## Staff Report to the Zoning Administrator

Application Number: **211155**

**Applicant:** Matson Britton Architects – Cove Britton  
**Owner:** Judi & Alex MacDonell  
**APN:** 028-242-25  
**Site Address:** 22702 E. Cliff Drive, Santa Cruz, CA

**Project Description:** (Continued from April 1, 2022 and May 20, 2022) Proposal to demolish an existing 2,474 square foot single-family dwelling and construct a two-story 6,064 square foot replacement dwelling with an attached 332.5 square foot one-car garage, an attached carport, a 310 square foot covered loggia, covered decks and a 4,463 square foot basement that includes a 283 square foot habitable hallway/bathroom, an attached non-habitable accessory structure (a 1,930 square foot storage room with a half-bathroom and a 2,250 square foot garage/workshop).

PROPOSED SECOND FLOOR PLAN  
SCALE: 1/8" = 1'-0"

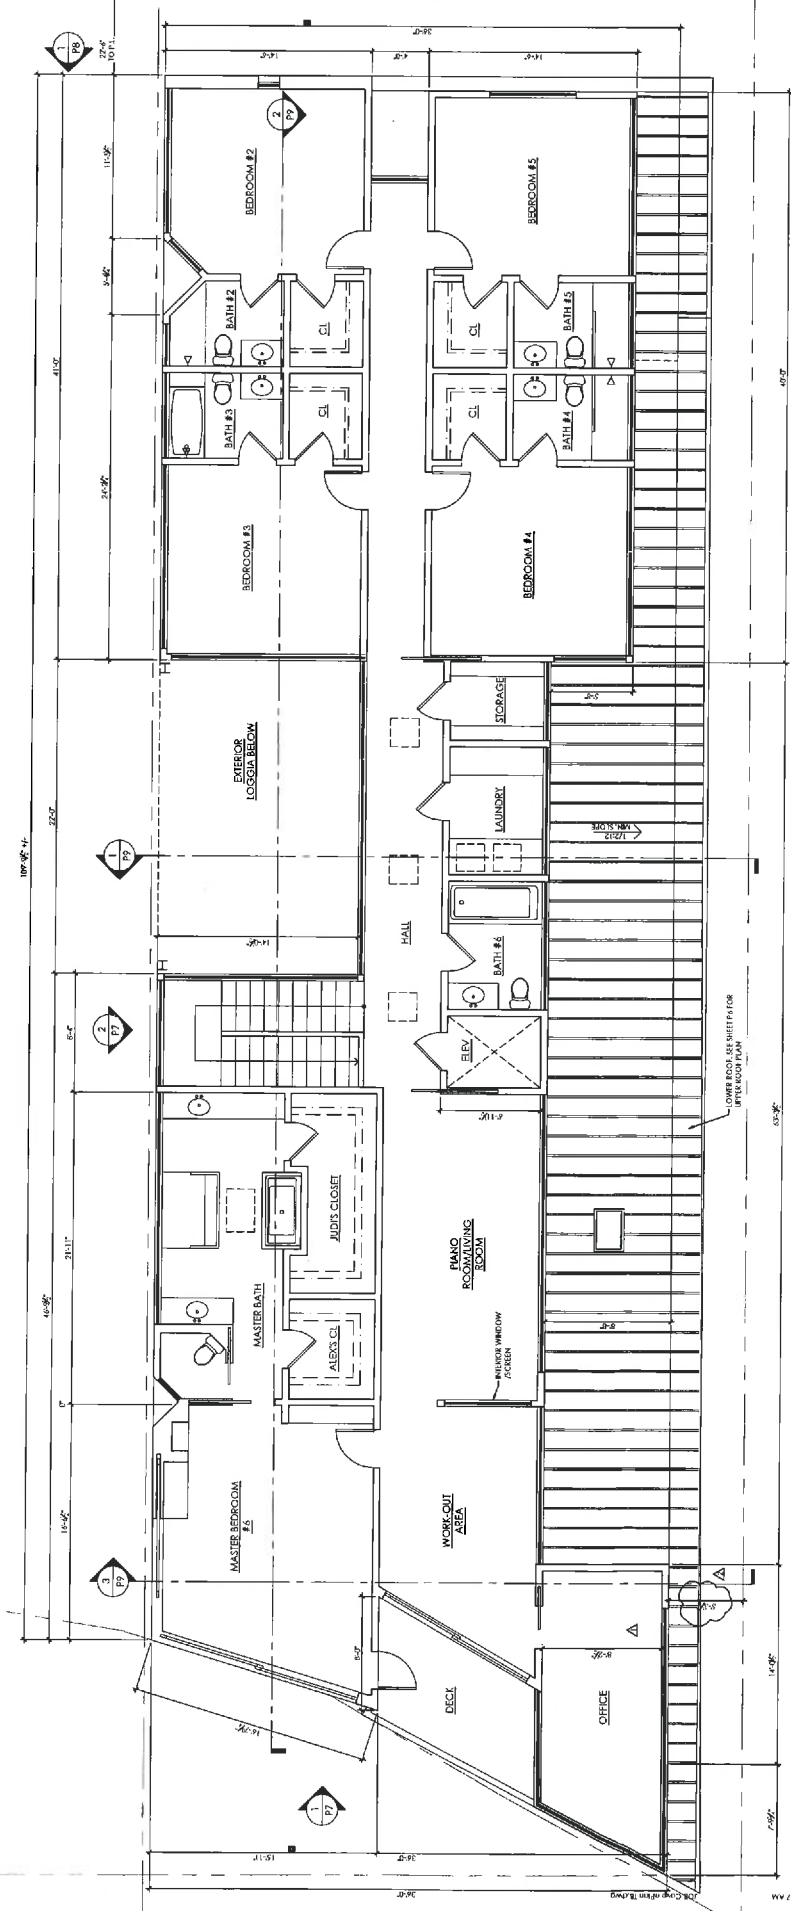
Furthermore, as required by County Code section 13.10.325(D)(10) the view to adjacent properties from large dwellings is required to be controlled. As currently shown on the submitted plans, the proposed dwelling includes an office space at the southern corner of the dwelling, extending back beyond the rear elevation of the existing house to the southeast. This room includes large windows that could have a significant potential impact on the privacy of the adjacent home in that they overlook the rear of the dwelling and its backyard area. Therefore, the proposed dwelling, as currently designed, does not comply with this requirement. Further, as previously set out in this report, the proposed office does not meet the required setbacks for the zone district, intended to protect adjacent homes from shading and other impacts and therefore, as currently proposed, the dwelling does not comply with the requirements of the County Design Review Ordinance.

As previously discussed, the proposed home does not appear to be in scale with and integrated with the character of the surrounding neighborhood, in that portions of the second floor encroach into the required setbacks required in the Pleasure Point Community Design "PP" Combining District. In addition, additional information and analysis will be required before the project Geotechnical (Soils) and Geologic Reports can be accepted and therefore the current project scope cannot be adequately defined. Review of the updated technical reports may result in modifications to the proposed development (i.e. an increased setback from the bluff); therefore, it cannot be determined that the project complies with the Local Coastal Program until revised technical reports have been accepted by the County Geologist and Geotechnical Engineer and an updated design has been submitted.
